TRANS-TEXAS WATER PROGRAM

West Central
Study Area
Phase I
Interim Report

VOLUME 5

**Comments Received from the
Advisory Committee for Public and Technical Input**

Figure 18

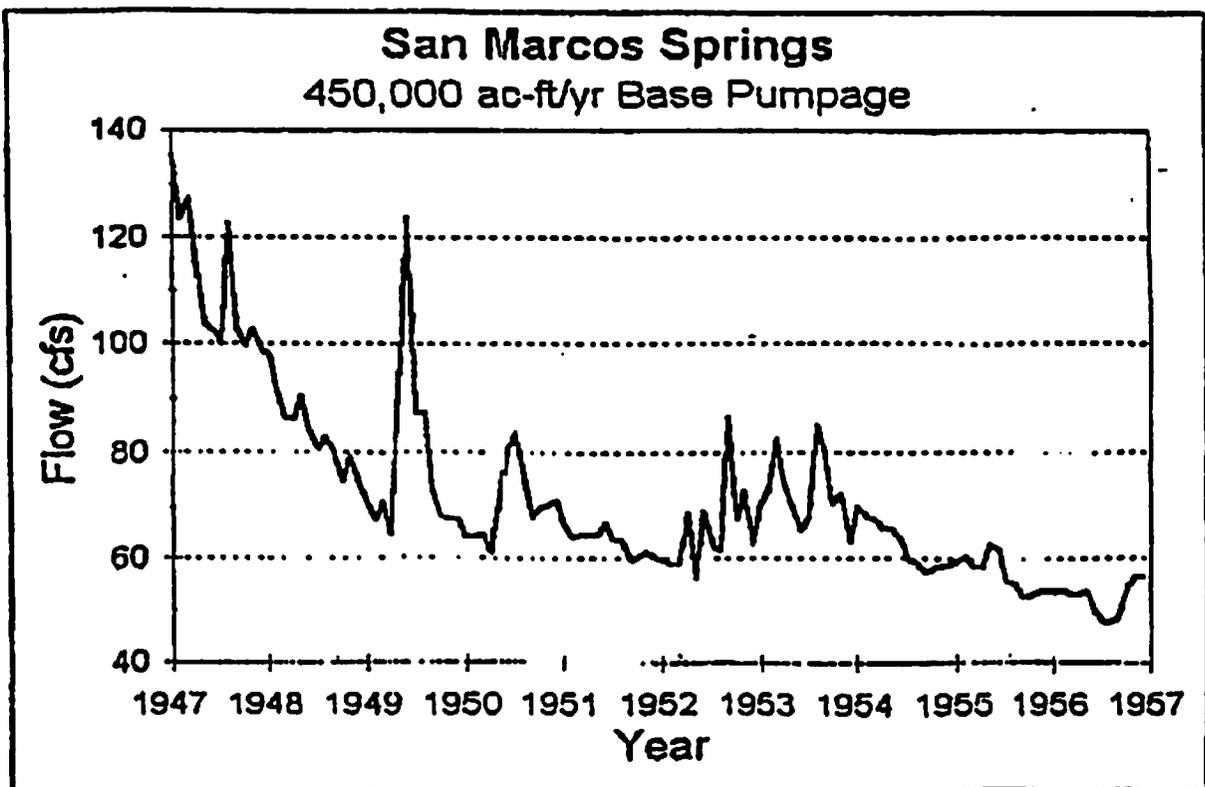
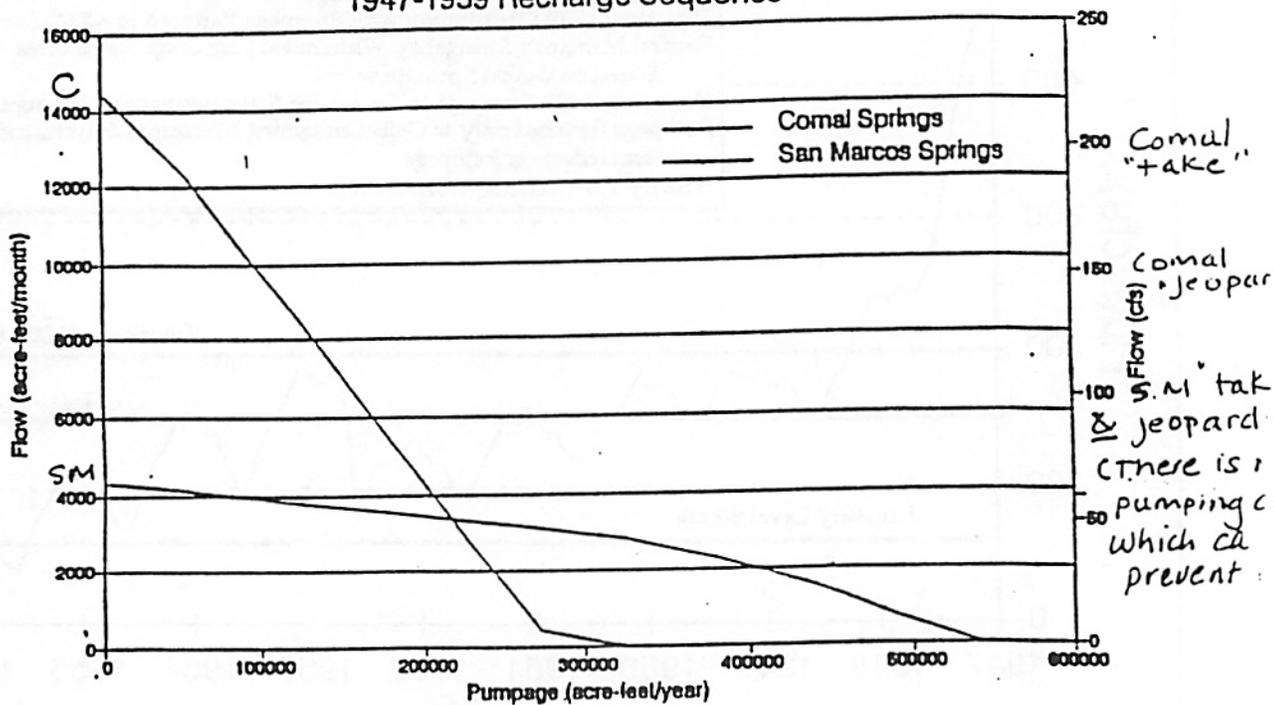
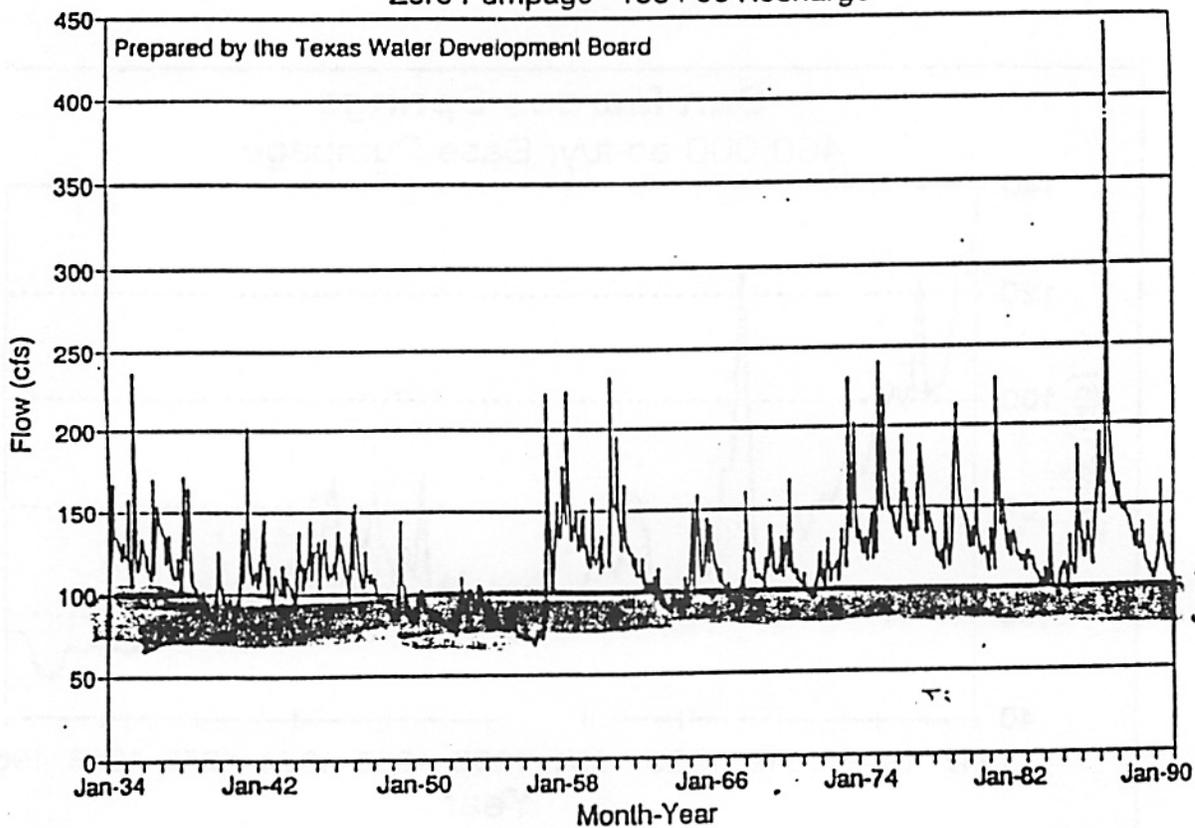
We know a lot about the first choice. We know first that the cutoff doesn't work to protect the spring species as required in a recovery plan or in order to get a take permit. Cutting aquifer pumping to 350,000 af/y allows Comal Springs to go dry in drought for about 6 years, and San Marcos Springs to fall below jeopardy levels 60% of the time.

Cutting pumping according to the August 1, Emergency Recovery Plan of up to 40% of July pumping still allows both Springs to fall below jeopardy. Even cutting pumping to zero allows San Marcos Springs to fall below jeopardy. Page 65 states that "Permanent reliable storage in the Edwards Aquifer is only that below the elevation of San Marcos Springs 574 msl."

The Texas Water Development Board recently ran the Federal Monitor's Emergency Withdrawal Plan for the Edwards Aquifer at the request of Representative Ciro Rodriguez. The plan makes reductions in pumpage when springflow at Comal Springs drops to various flow levels. The base pumping level for this plan was 450,000 ac-ft/yr. Representative Rodriguez requested July 1994 water-levels and pumpage, however this data was not available as of yet for the model.

Comal "take"
Comal "Jeopard"
S.M. "tak & Jeopard"
(There is pumping which can prevent)
